To:	James Taylor	From:	Drainage (Barney Taylor)
------------	--------------	--------------	--------------------------

Planning App Ref:	PL/2026/03545
Service Ref:	Drainage
Date:	13/07/2026

Outline Planning Application for up to 400 dwellings (Class C3 use), land for a Local Centre, accommodating commercial, business and service uses (Class E use), drinking establishment and hot food takeaway (Sui Generis); and local community uses (Class F2); open space and landscaping to include natural green space, amenity green space, area of formal play, allotments and community orchard, sustainable drainage infrastructure and ground remodelling. All matters reserved except for the formation of a new vehicular access and cycle and pedestrian access including emergency access onto the B4528.

Land east of Showell Farm, Chippenham, Wiltshire

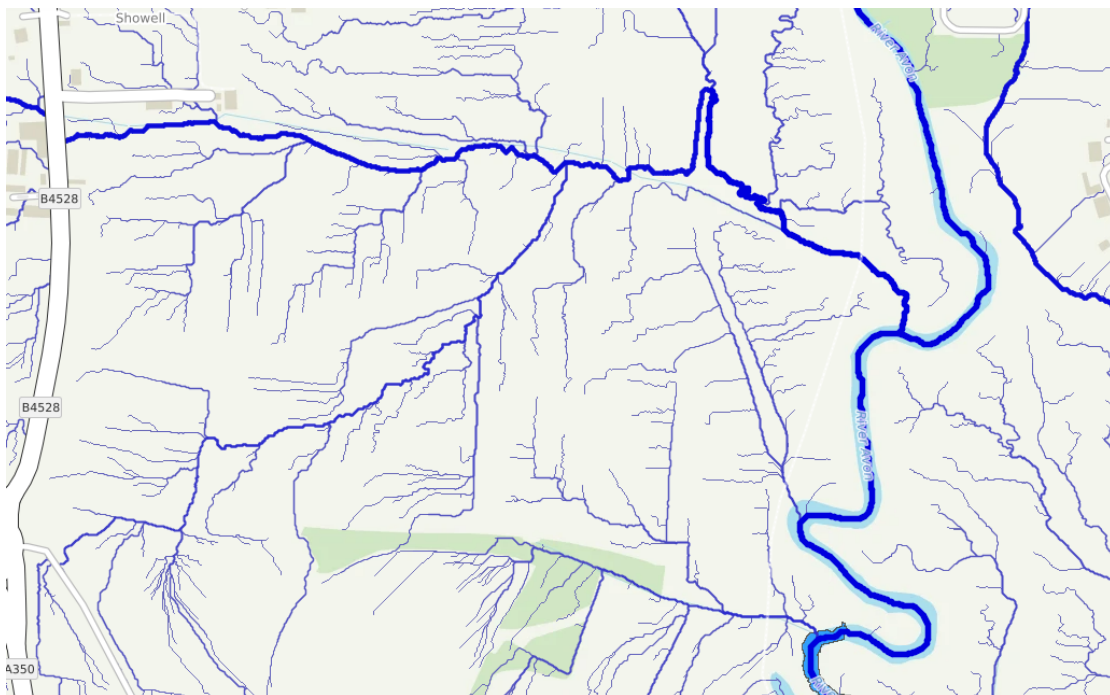
- a) Observing the site's topography (snip below), there are several existing flow paths running across the site, primarily from the southern portion of the site & towards the drainage channel, prior to outfalling into the Avon.

Whilst it is noted the applicant has taken a sequential approach with regards to developing the area within Flood Zone 1 only, it is unclear how flow paths will interact with the site & the applicant must demonstrate that flood risk will not be increased elsewhere.

In accordance with Standard 3 of the National Standards for SuDS the applicant must outline the overland exceedance on the drainage plan for flows in excess of the 1 in 100 year plus climate change (40%) rainfall event to demonstrate there will be no adverse flood risk to the development or elsewhere as a result of the proposals

It is noted in Figure 2 there is an existing drainage channel running west to east just to the north of the developable area at the site. The applicant must confirm this channel will be preserved and demonstrate that there will be no increase in flood risk because of the development.
